Access Compliance Report

Public Rights-of-Way

(Curb Ramps)

Intersection ID: 23292	Main Street: SHARON_RD_WEST	Cross Street: RIVERBIRCH_DR	Location: SE
ADA ID: D454FE82203B	Ramp Type: PerpDiag	Initial Pass/Fail: Fail	Overall Compliance: No
Severity Score: 22.5			
Codes/Mitigation Info/Possible Solution		Field Measurements/Component Compliance

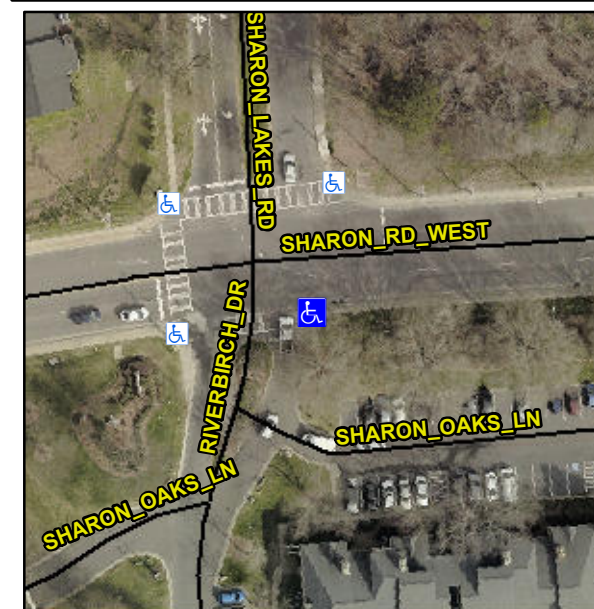
Not Found, R304.5.1, R304.2.2

Compliance	Description	Data	Compliance	Description	Data
N/A	Ramp Length (in)	58.0	No	Ramp Slope (%)	11.6
No	Ramp Width (in)	41.0	Yes	Ramp XSlope (%)	2.1
N/A	Flare Type LT	N/A	N/A	Flare Type RT	N/A
N/A	Flare Slope LT (%)	N/A	N/A	Flare Slope RT (%)	N/A
N/A	Flare Traversable LT?	N/A	N/A	Flare Traversable RT?	N/A
N/A	Landing Length (in)	N/A	N/A	DWS Provided?	N/A
N/A	Landing Width (in)	N/A	N/A	DWS Contrast?	N/A
N/A	Landing Slope (%)	N/A	N/A	DWS Length (in)	N/A
N/A	Landing X Slope (%)	N/A	N/A	DWS Full Width?	N/A
N/A	Landing Curb? (Y/N)	N/A	N/A	DWS Offset (in)	N/A
N/A	Shared Landing?	N/A			
N/A	Gutter Ponding?	N/A	N/A	Gutter Slope (%)	N/A
N/A	Gutter Lip Ht (in)	N/A	N/A	Gutter X Slope (%)	N/A
N/A	Painted X Walk1?	No	N/A	Painted X Walk2?	Yes
	X Walk 1 Direction	To NE		X Walk 2 Direction	To W
N/A	X Walk 1 Width (in)	N/A	N/A	X Walk 2 Width (in)	104.0
	X Walk 1 Slope (%)	2.7		X Walk 2 Slope (%)	1.0
	X Walk 1 X Slope (%)	1.4		X Walk 2 X Slope (%)	1.6

Remove & Replace Curb Ramp With Two New Directional Ramps or Equivalent.
